Public Hearing on Multiple-Family Commercial PUD Plan Application known as One University Place Submitted by Maxwell Development, LLC concerning property presently owned by St. Andrew Presbyterian Church and property to the east.

**City of University Heights, Iowa
Special Meeting of City Council
Wednesday, May 27th, 2015
University Club – east entrance
7:00-9:00pm
Meeting called by Mayor Louise From**

May 27, 2015 – City Attorney's Report re One University Place

One University Place Planned Unit Development (PUD) Report
U-Heights Building Inspector Terry Goerd

SHEET NUMBER
C-102

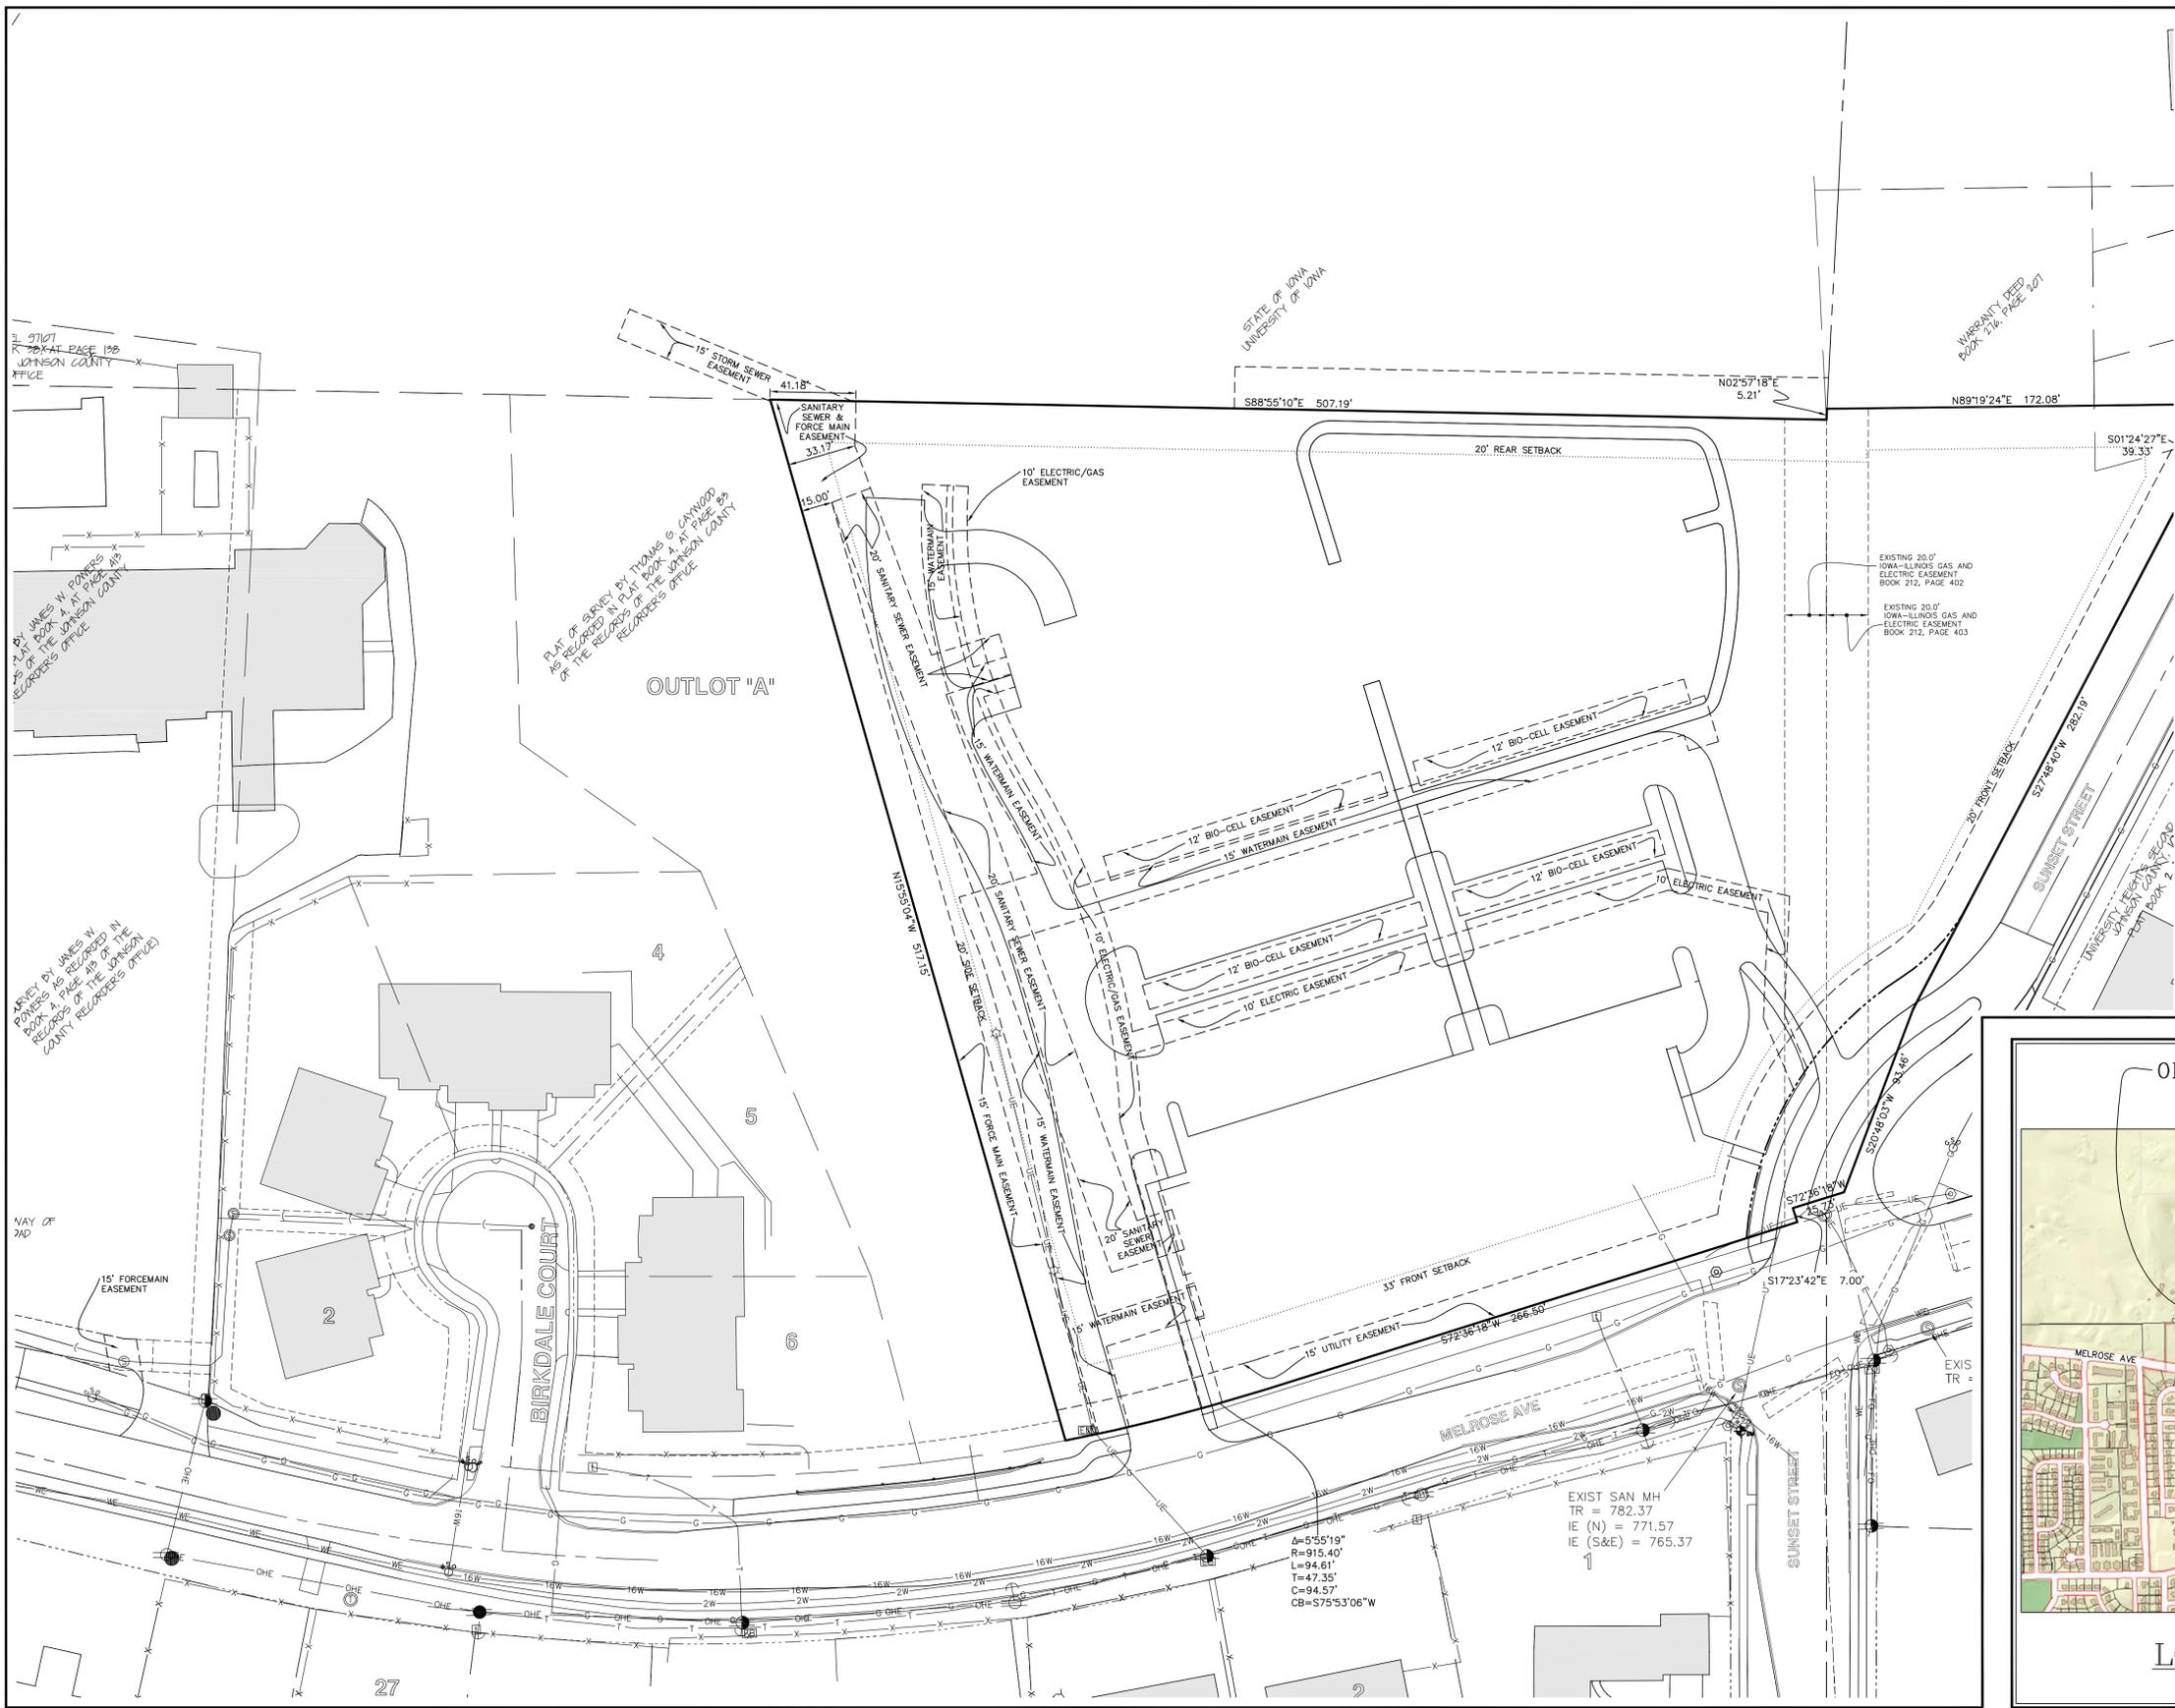
access for future maintenance or repairs. **This need for an additional easement(s) should be acknowledged on Sheet C-102 with approximate locations shown.**

The City of University Heights will require stormwater management easements for each BMP installed on the site for the purpose of inspection and repair. **This should be acknowledged on Sheet C-102 with approximate locations shown.**

SHEET NUMBER
C-103

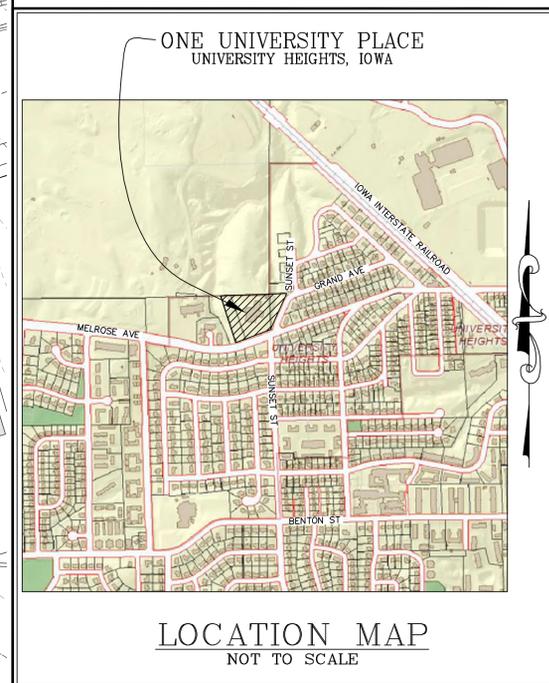
Refer to Sheet C-103 and C-104. These sheets are to show sensitive slope areas, and where the proposed construction is located relative to these areas. **The delineation of steep and critical slope areas is missing from each sheet, and will need to be resubmitted.**

SHEET NAME
SITE GRADING AND EROSION CONTROL PLAN AND SENSITIVE AREAS SITE PLAN

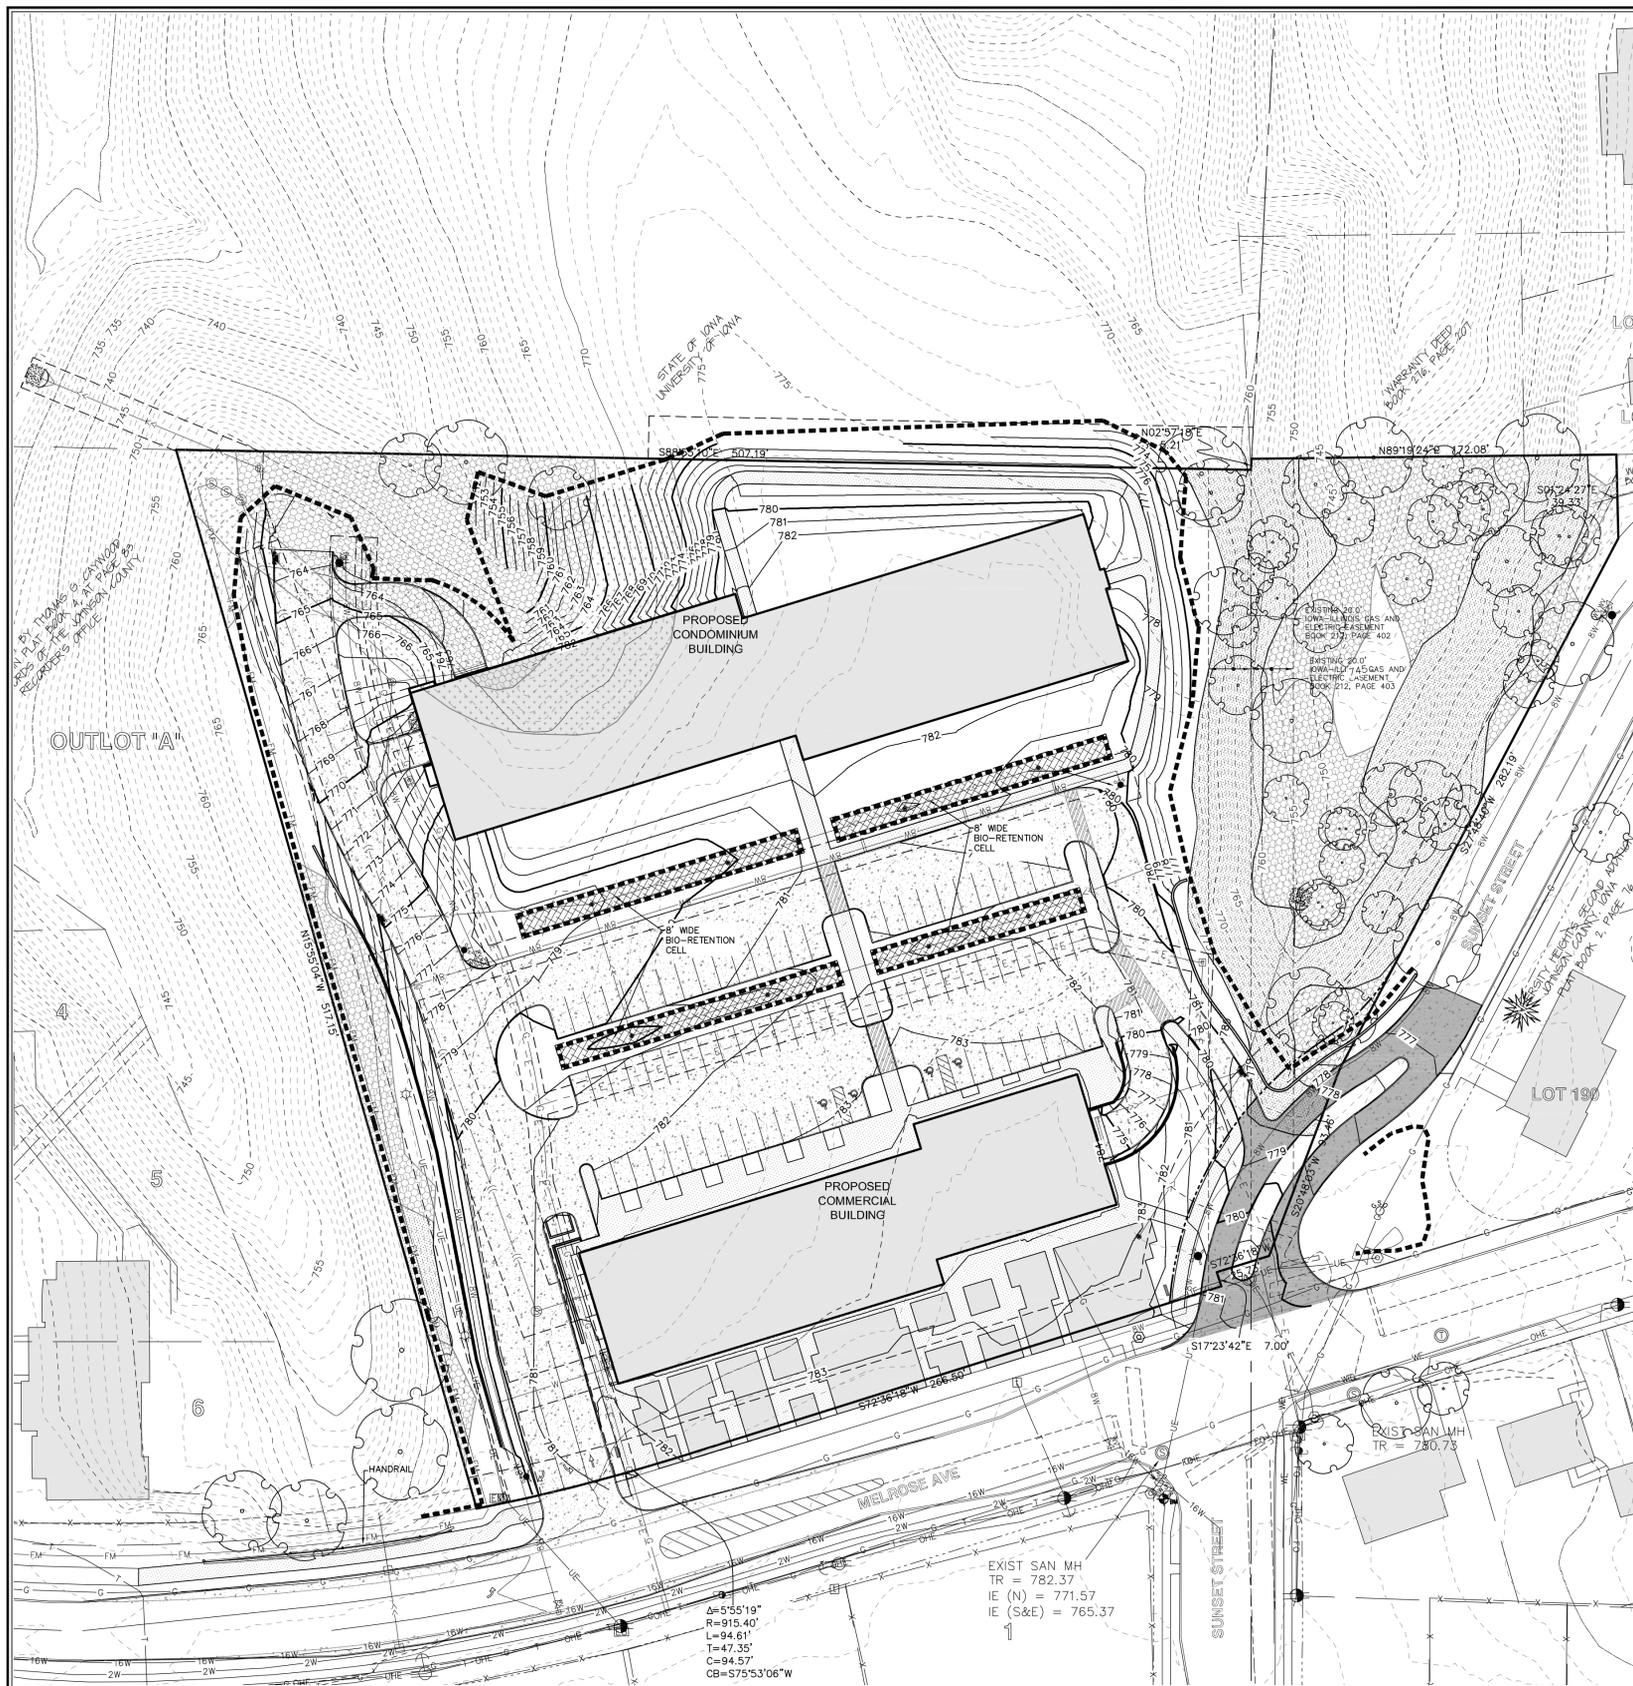
Sheet C-104 is labeled as the erosion control plan. It indicates silt fence being installed along the perimeter of the site and along the top of the east ravine. **Additional erosion control measures to encompass all utility and other project work occurring beyond the property line should be shown on this sheet.**

- ii. The council needs to determine if they are in agreement with the concepts shown for new grading around the site, as well as the proposed building, paving, and utility work that will take place across portions of the existing steep, critical and protected slope areas as shown on Sheet C-104.

Figure 3: AM Peak Hour Left-Turn Lane Warrant Not Warranted (L= % of Left-Turns in Advancing Volume)

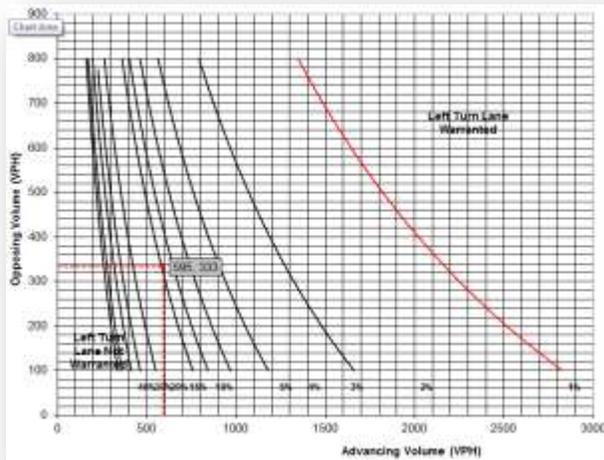
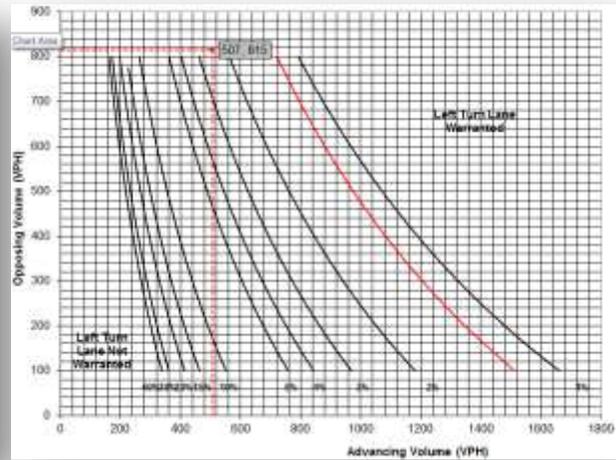
To complete the eastbound left-turn lane warrant analyses at the intersections adjacent to the proposed development, the estimated development trip generation figures from **Table 1** were added to the existing peak hour traffic data collected in February 2014. **Figures 3 and 4** indicate that a dedicated eastbound left-turn lane is not warranted at the intersection of Melrose Avenue and Sunset Street during peak hours.

Figure 5: AM Peak Hour Left-Turn Lane Warrant Warranted

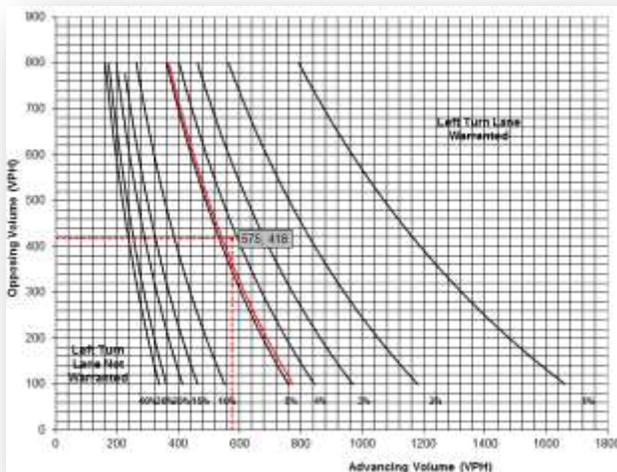
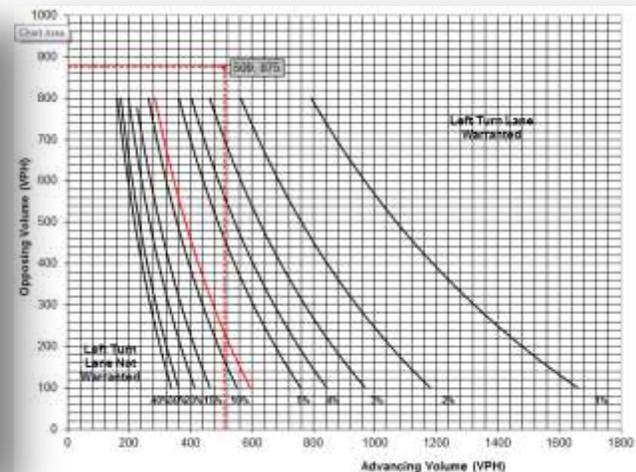
Turn Lanes: As proposed in the PUD submittal, staff agrees that a dedicated left-turn lane for eastbound traffic at the main entrance is necessary. This turn-lane will remove turning traffic from the through travel lane and minimize delay to eastbound traffic. An eastbound left turn lane is not necessary at the Sunset/Melrose intersection (see attached memorandum).

Figures 5 and 6 show that an eastbound dedicated left-turn lane is warranted at the Main Entrance during both peak hours. The left-turn lane is warranted during the PM peak period even with a 50% reduction in estimated left-turning residential traffic (accounting for 2006-2010 American Community Survey information shows that 43% of University Heights residents used modes other than private vehicles to get to work).
